Access Compliance Report

Public Rights-of-Way

(Curb Ramps)

Intersection ID: 10023888	Main Street: COMMUNITY_HOUSE_RD	Cross Street: N/A	Location: SW
ADA ID: 2CFAD5023C0B	Ramp Type: BlendTrans2	Initial Pass/Fail: Fail	Overall Compliance: No
Severity Score: 8.75			
Codes/Mitigation Info/Possible Solution		Field Measurements/Component Compliance

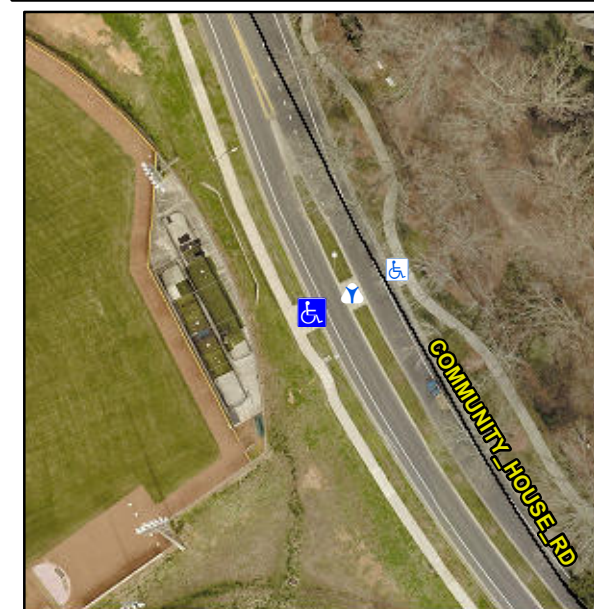
NO LNDG

Not Found, R304.5.1

Compliance	Description	Data	Compliance	Description	Data
N/A	Ramp Length (in)	168.0	Yes	BlendTrans Slope (%)	3.6
No	Ramp Width (in)	45.5	Yes	BlendTrans XSlope (%)	1.0
N/A	Flare Type LT	N/A	N/A	Flare Type RT	N/A
N/A	Flare Slope LT (%)	N/A	N/A	Flare Slope RT (%)	N/A
N/A	Flare Traversable LT?	N/A	N/A	Flare Traversable RT?	N/A
N/A	Landing Length (in)	N/A	N/A	DWS Provided?	N/A
N/A	Landing Width (in)	N/A	N/A	DWS Contrast?	N/A
N/A	Landing Slope (%)	N/A	N/A	DWS Length (in)	N/A
N/A	Landing X Slope (%)	N/A	N/A	DWS Full Width?	N/A
N/A	Landing Curb? (Y/N)	N/A	N/A	DWS Offset (in)	N/A
N/A	Shared Landing?	N/A			
N/A	Gutter Ponding?	N/A	N/A	Gutter Slope (%)	N/A
N/A	Gutter Lip Ht (in)	N/A	N/A	Gutter X Slope (%)	N/A
N/A	Painted X Walk1?	No	N/A	Painted X Walk2?	N/A
	X Walk 1 Direction	To NE		X Walk 2 Direction	N/A
	X Walk 1 Width (in)	N/A		X Walk 2 Width (in)	N/A
	X Walk 1 Slope (%)	5.1		X Walk 2 Slope (%)	N/A
	X Walk 1 X Slope (%)	0.9		X Walk 2 X Slope (%)	N/A

N/A	Ramp inside XWalk1?	N/A	N/A	Ramp inside XWalk2?	N/A
	Road Slope (%)	0.9		Clear Space?	N/A
	Road X Slope (%)	5.1	N/A	Clear Space to XWalk (in)	N/A
N/A	Any Obstructions?	N/A	N/A	Storm Grate/Utility Hazard?	N/A
	Obstruction Type			Storm Grate/Utility Type	
		N/A			N/A
			Yes	Surface Condition? (G/P)	Good
			No	Curb Slope (%)	7.2

Remove & Replace Curb Ramp With Two New Directional Ramps or Equivalent.
